**Ref.: SG15-TD144/PLEN-Annex C**

**Title:** LS/r to MEF Forum liaison on MEF 10.4 work on one-way frame delay (reply to MEF-LS114)

**LIAISON STATEMENT**

**Figure 9 - Frame Delay for Service Frame**

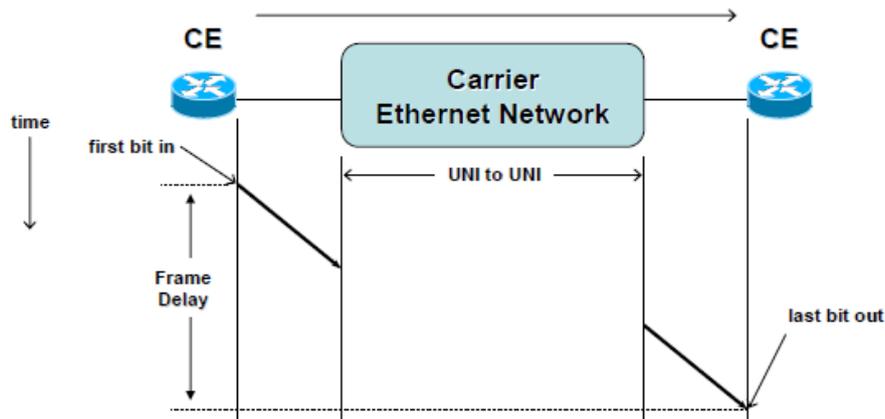
- Contrary to the Y.1731 text above that uses only two points in time to describe one-way frame delay, the proposed MEF 10.4 content uses two then four points in time apparently for no other reason than to clarify the text below Figure 9/MEF 10.3;
- The terms  $UNI_1$  and  $UNI_2$  are mentioned in the text preceding Figure 16 but are not used in this Figure; and
- Your sentence “The definition of One-way Frame Delay for a Service Frame is the one-way delay that includes the delays encountered as a result of transmission of the Service Frame across the ingress UNI ( $t_1 - t_0$ ) and egress UNI ( $t_3 - t_2$ ) as well as that introduced by the CEN ( $t_2 - t_1$ )” could be understood as implying that the CEN does not include the ingress UNI or egress UNI.

Figure 16 – One-way Frame Delay for Service Frame

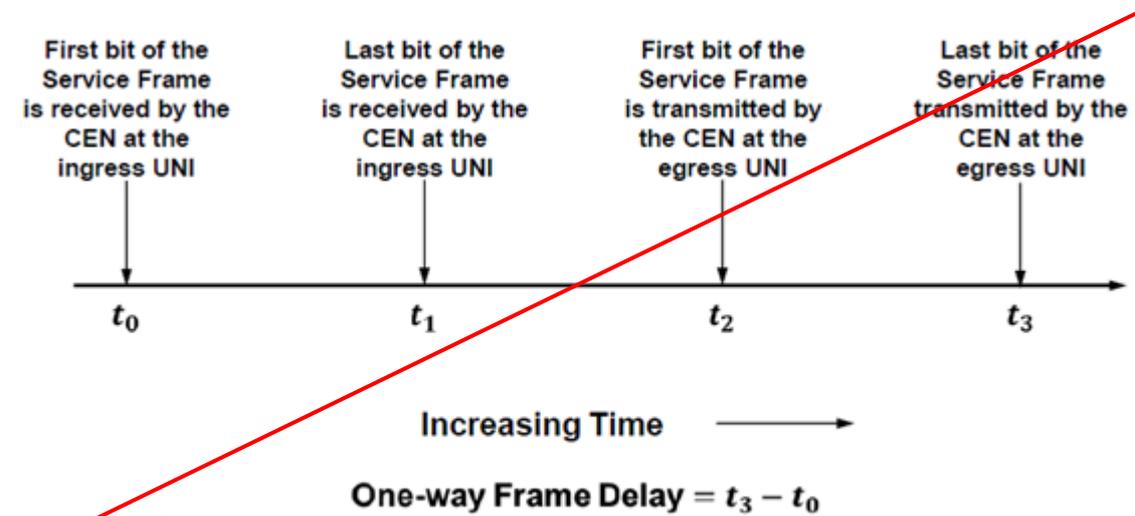
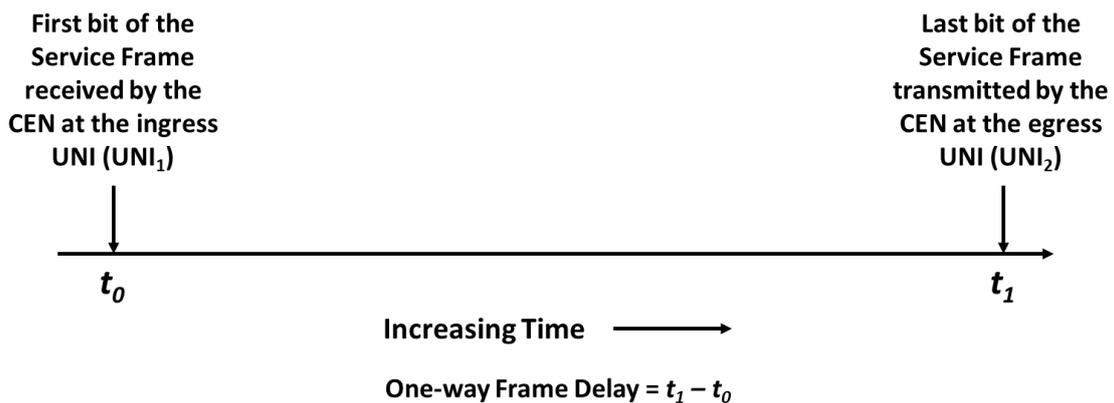
In view of the above but also to ensure reasonable alignment and avoid any confusion, we would suggest simplifying your proposed MEF 10.4 content as follows:

The One-way Frame Delay for a Service Frame that ingresses at  $UNI_1$  and results in a Service Frame that egresses at  $UNI_2$  is defined as the time elapsed from the reception by the CEN of the first bit of the

Ingress Service Frame at the ingress UNI until the transmission by the CEN of the last bit of the first corresponding Egress Service Frame at the egress UNI. If the Service Frame is erroneously duplicated in the Operator CEN and multiple copies delivered to UNI<sub>2</sub>, the delay is based on the first such copy delivered. This definition is illustrated in Figure 16.

The definition of One-way Frame Delay for a Service Frame is the one-way delay that includes the delays encountered as a result of transmission of the Service Frame across the CEN, i.e., from the ingress UNI ( $t_1 - t_0$  UNI<sub>1</sub>) and to the egress UNI ( $t_3 - t_2$  UNI<sub>2</sub>), as well as that introduced by the CEN ( $t_2 - t_1$ ). Note that the One-way Frame Delay does not include delays on the SE side of the UNI, e.g., propagation across a cable attaching an SE router to the UNI is not included.
